Coalbed Methane Stream Depletion Assessment Study – Piceance Basin, Colorado

S.S. PAPADOPULOS & ASSOCIATES, INC.
Boulder, Colorado

April 2008

Only one set of written comments have been received and those were submitted via Email on February 8, 2008 by Wright Water Engineers (WWE) on behalf of Gunnison Energy Corporation (GEC). WWE had requested, and were granted, an extension of the comment deadline. The first set of comments by WWE, under the heading “General Comments”, addressed general concepts used in the study or aspects of report content whereas the second set, under the heading “Detail Comments”, addressed specific items in the text, tables or figures that appeared to be problematic. Each of WWE’s comments are reproduced below with responses by CGS and SSPA following in italics

Figure 5.1 Piceance Basin CBM Subunits

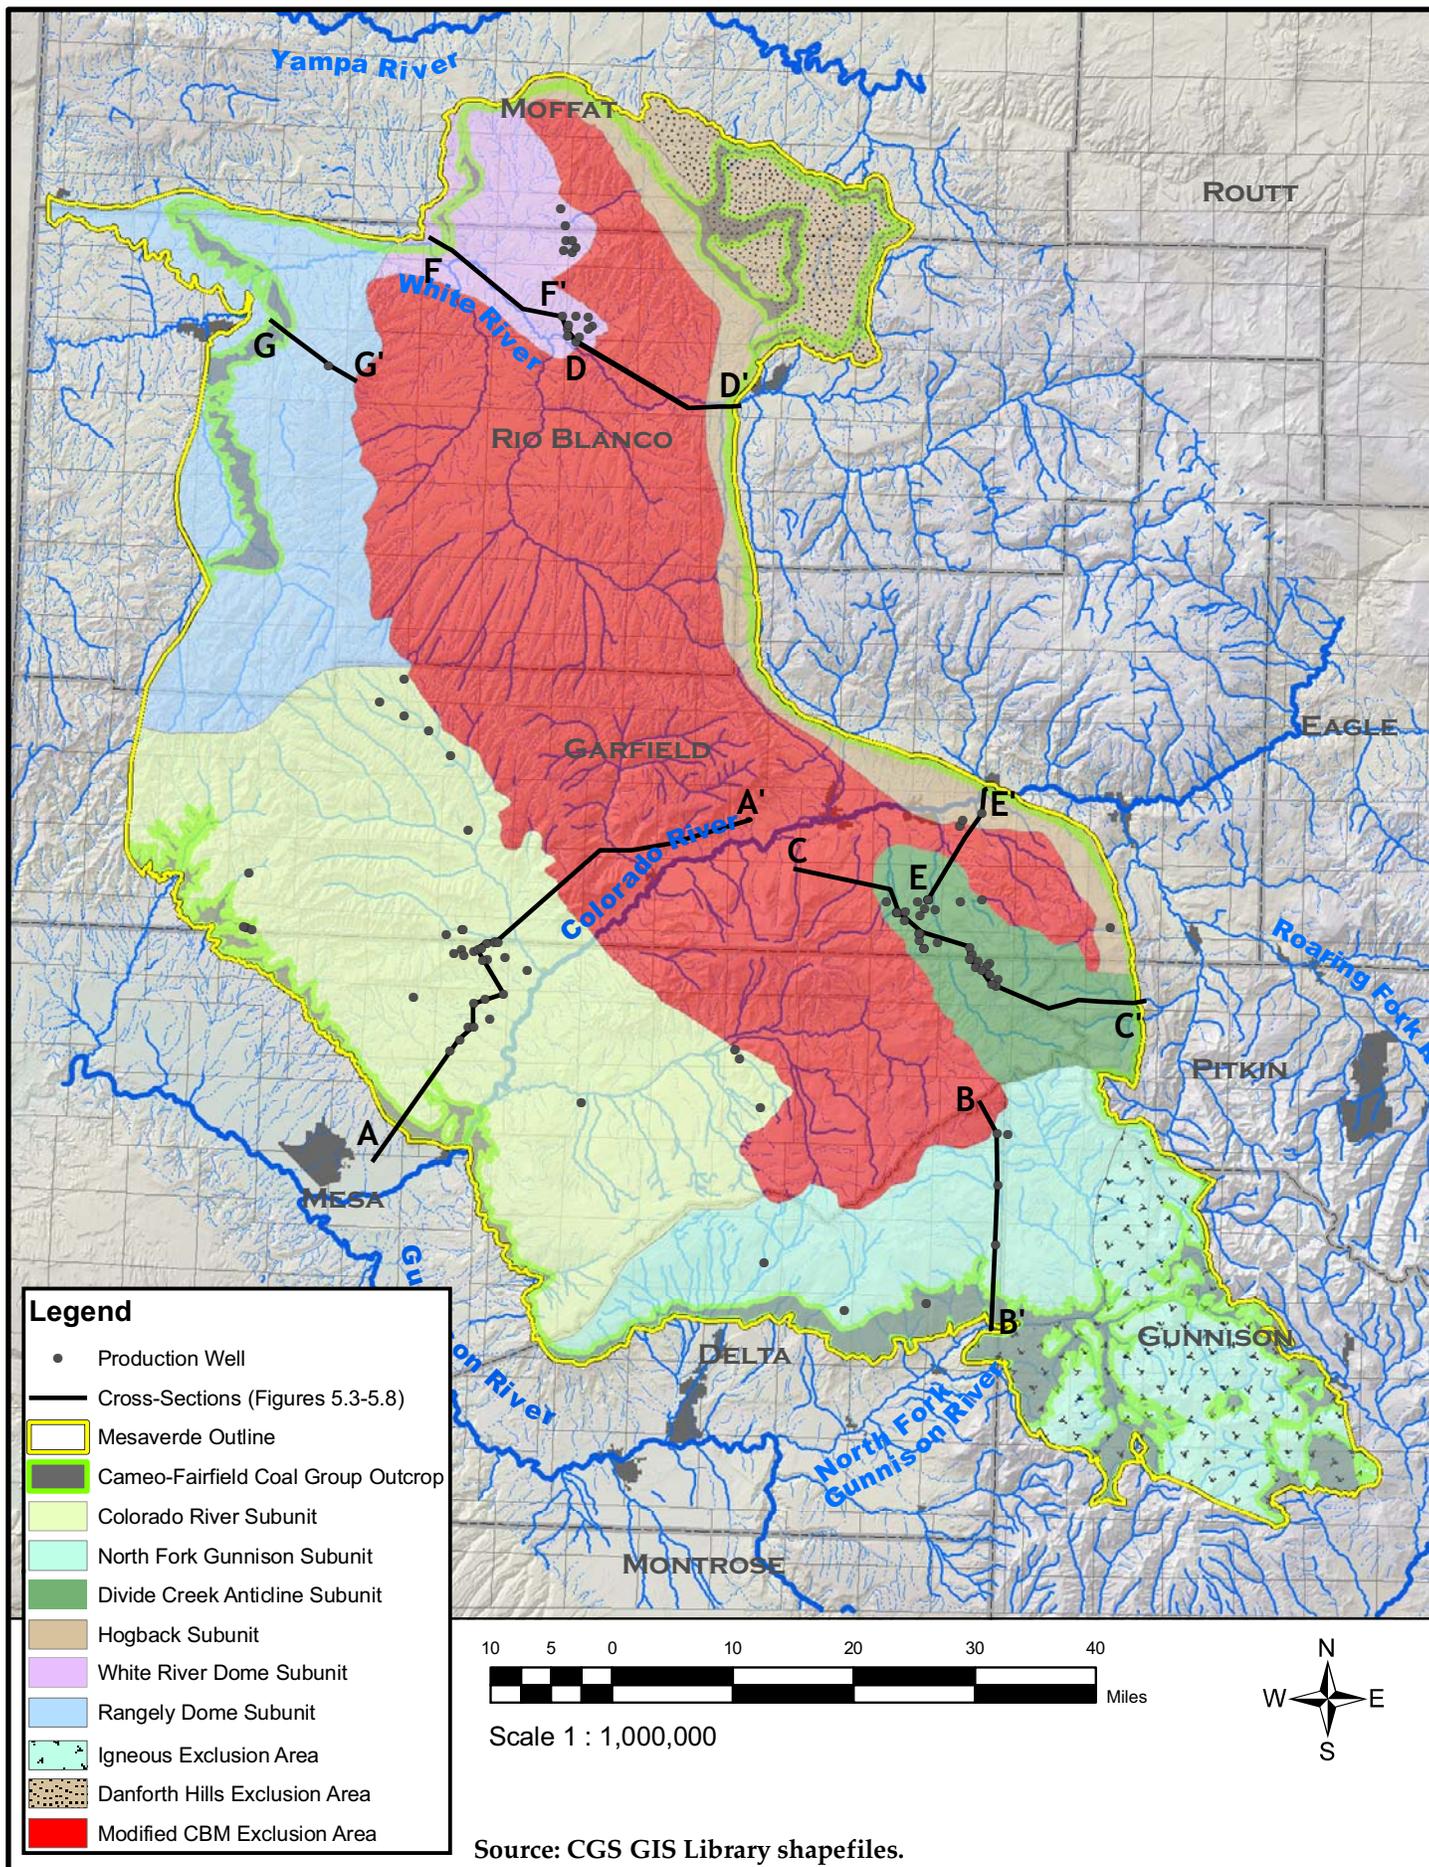
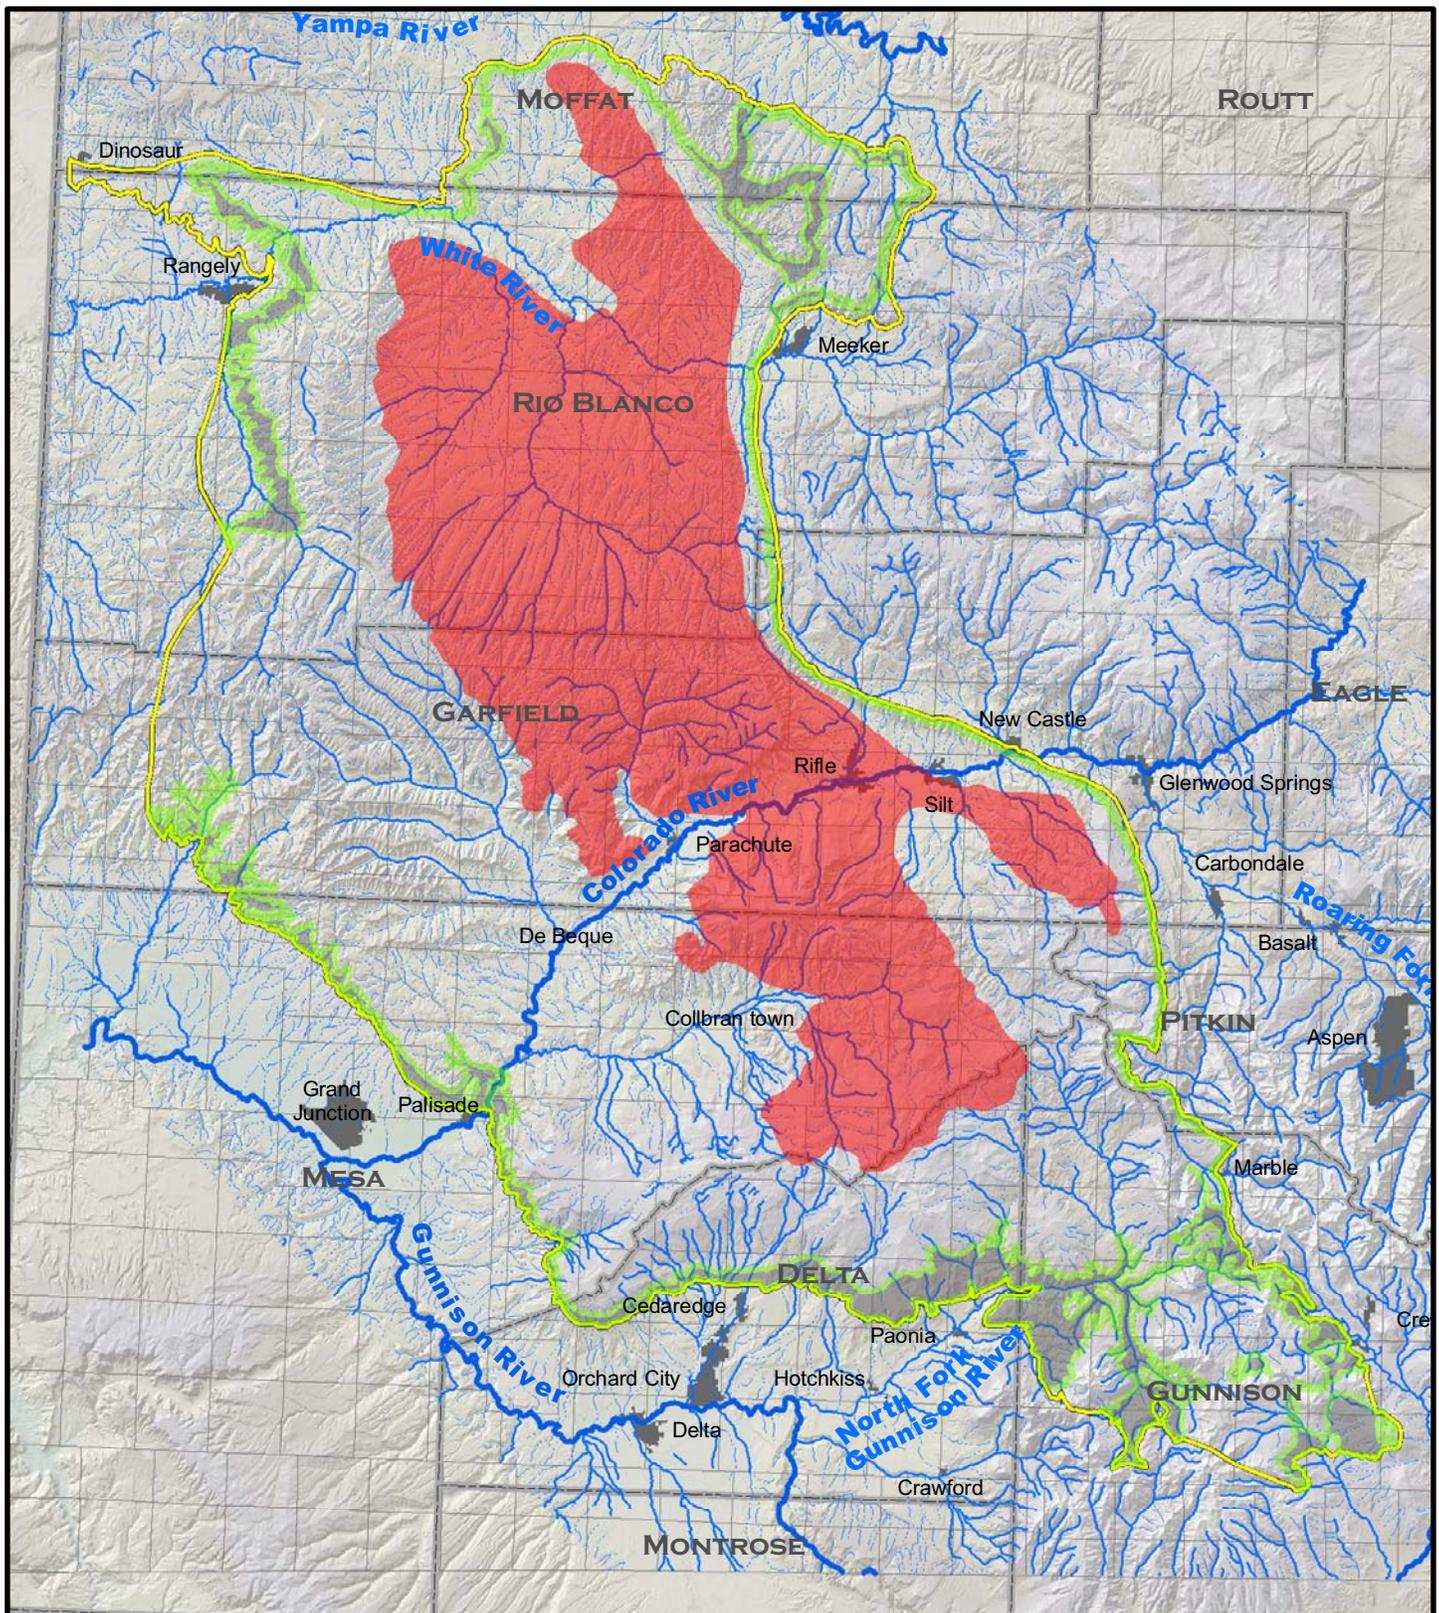
8. Section 5.4 (Page 29, 1st Paragraph, 2nd Sentence) – Figure 5.1 includes a modified representation of the USGS’ CBM exclusion area. Specific reference is made to the Study.

Response: The depiction of the USGS Mesaverde Group Coalbed Methane Exclusion Unit and the modified CBM exclusion area used in this study are reversed in Figure 3.8, Figure 5.1, and several other figures in the report. These figures will be corrected.

Figure 6.1 Area with Potential for Depletion to Exceed 0.1% in 100 Years

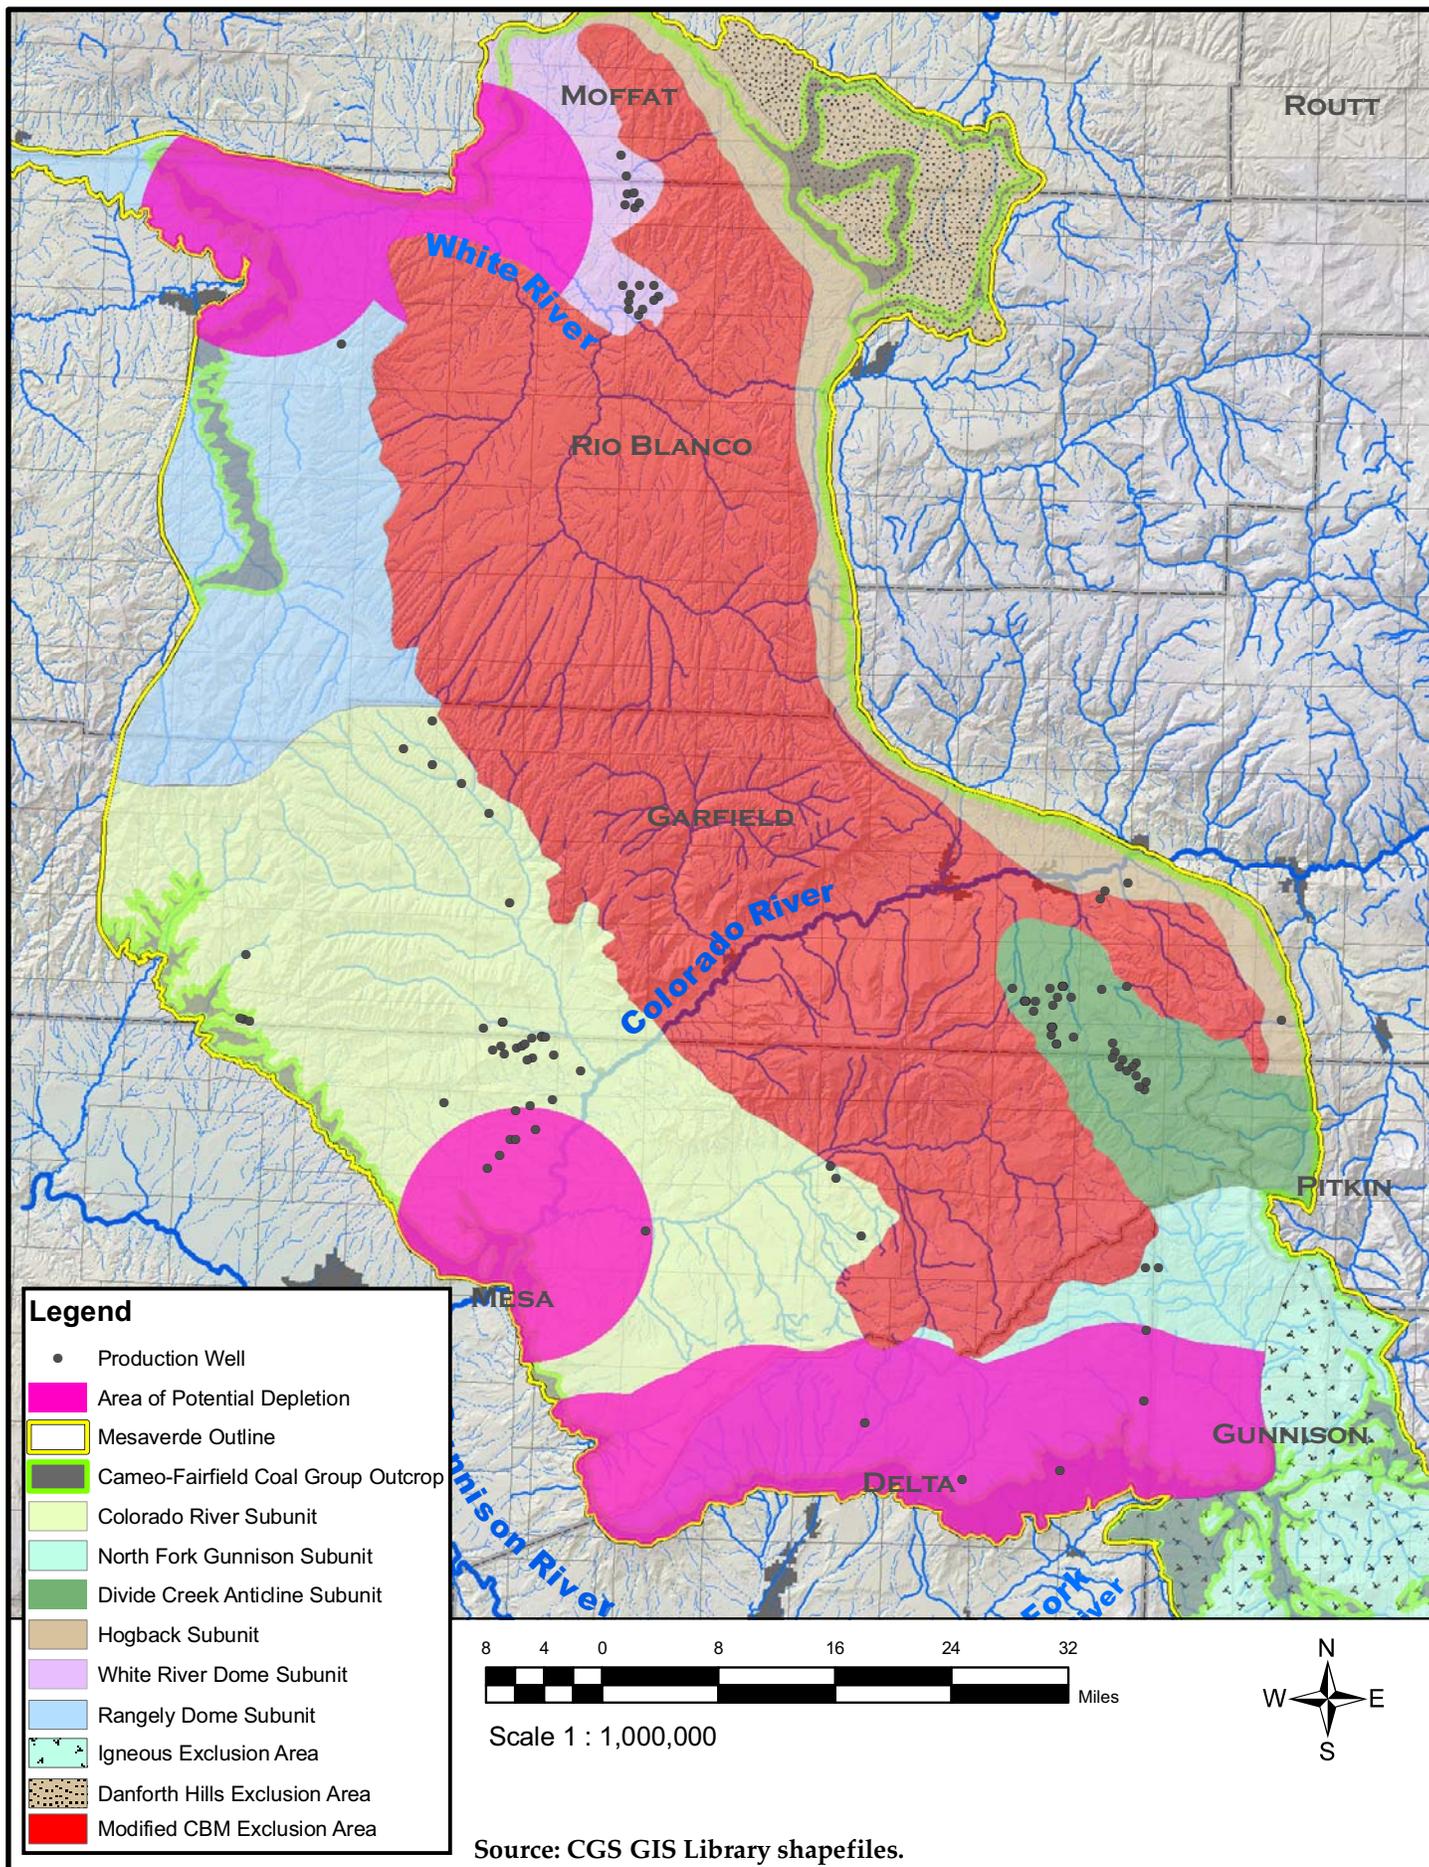
4. A likely interpretation of Figure 6.1 is that water produced from CBM development anywhere in the Piceance Basin other than those identified in pink as "Areas of Potential Depletion" is nontributary. It is unclear if that was the intent of this figure; nonetheless, that has been the interpretation of at least one operator who contacted WWE regarding the relevancy of this report to their operations. WWE recommends that the authors supplement the report text to address the significance of this figure as it relates to potential future nontributary groundwater claims.

5. Four specific areas of Potential Depletions are identified in the Study and specifically represented on Figure 6.1. It appears as if the 8.8-mile offset to the tributary/nontributary line is based upon the point at which the surface stream crosses the coal-bearing portion of the Mesaverde Formation in the White River Dome, Rangely Dome and Colorado River subunits but not in the North Fork Gunnison River subunit. In the latter case, it appears that the 8.8-mile offset is from the exposed outcrop. What is the explanation for this difference? Particularly in light of the statement in the *North Fork Gunnison River Subunit* Section (Page 31, 4th Paragraph, 2nd Sentence) stating that "Even though methane derived from the coals is known to be present in this area, it is being excluded from this evaluation because the potential for CBM development is limited."

inclusion of this subunit in Figure 6.1 as an area of potential depletion while excluding it from the quantitative assessment of stream impacts requires further explanation.

Response: Such a position in this document is beyond the scope of this study. This assessment, and the supporting modeling efforts, were designed to provide a first-order estimate of CBM-producing areas that may be tributary or non-tributary based on data made available for the study. At present, any operator claiming a non-tributary designation for beneficial use of CBM water in the Piceance Basin will be required to submit a technically defensible validation for that claim to DWR.

The report text has been modified to clarify this situation.

Response: The inclusion of the entire outcrop within this subunit was based on several factors related primarily to the elevated precipitation upslope from the outcrop on Grand Mesa. A number of perennial streams transverse the outcrop and it is probable that the upper weathered face of the outcrop bears water in most areas. This condition was explained in detail in a report prepared by WWE for GEC describing the hydrologic conditions of the region (Wright Water Engineers, 2003a).
